DISCOVERY  
VS  
Current IIGS  
ERS

The following is a list of the changes from the current IIGS to the DISCOVERY, and they are divided into groups depending on the scope of the change:

**TIMING**

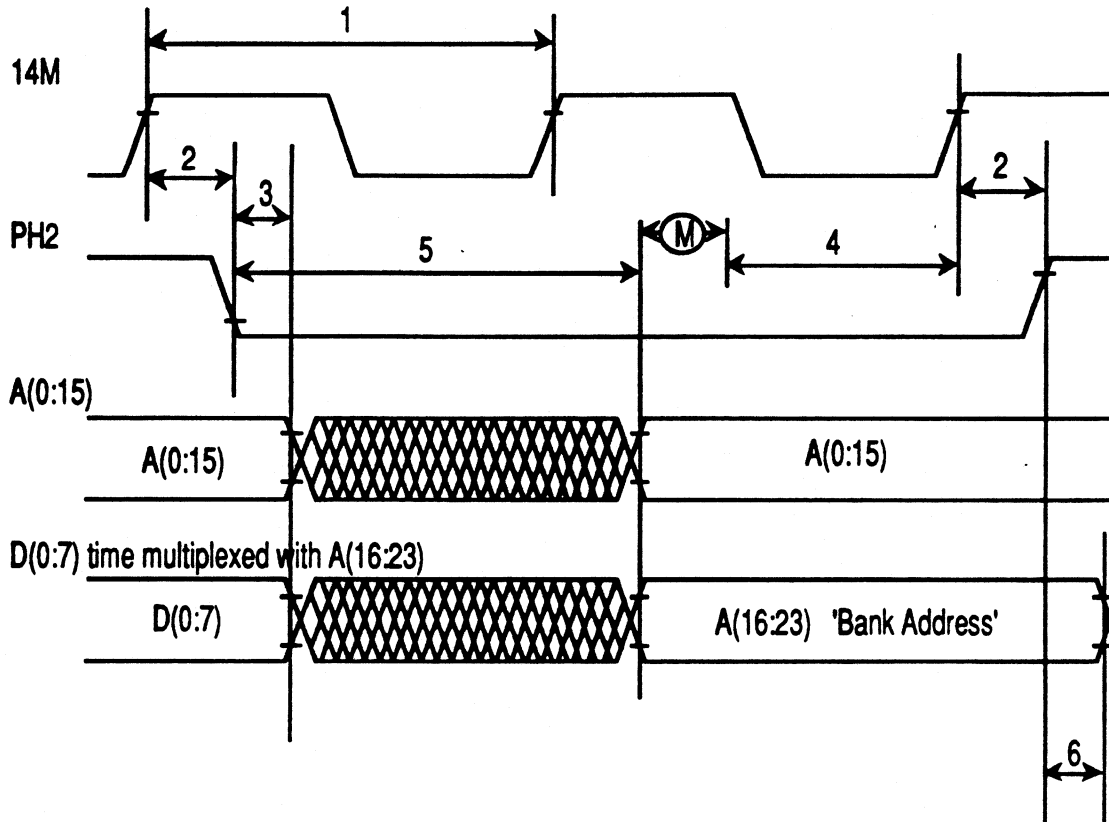
ITEM	DESCRIPTION	MIN	MAX
1	CYA master clock period	70ns	
2	14M to PH2 delay		15ns
3	A(0:15) and D(0:7) hold	10ns	
4	Internal CYA A(0:23) setup		40ns
5	PH2 to A(0:23) delay		70ns
6	A(16:23) hold	10ns	
M	System Margin	15ns

The Internal CYA A(0:23) setup of 40ns Max. is longer than the equivalent Internal FPI setup of 25ns Max. by 15ns. This forced the PH2 to A(0:23) delay to be pulled in from the standard 65C816 4Mhz Spec. (tBAS = 90ns Max. & tADS=75ns Max.) by 20ns & 5ns respectively to allow a sufficient system timing margin.

Any processor replacement in the DISCOVERY system needs to allow for this timing difference from the current IIGS to work properly.
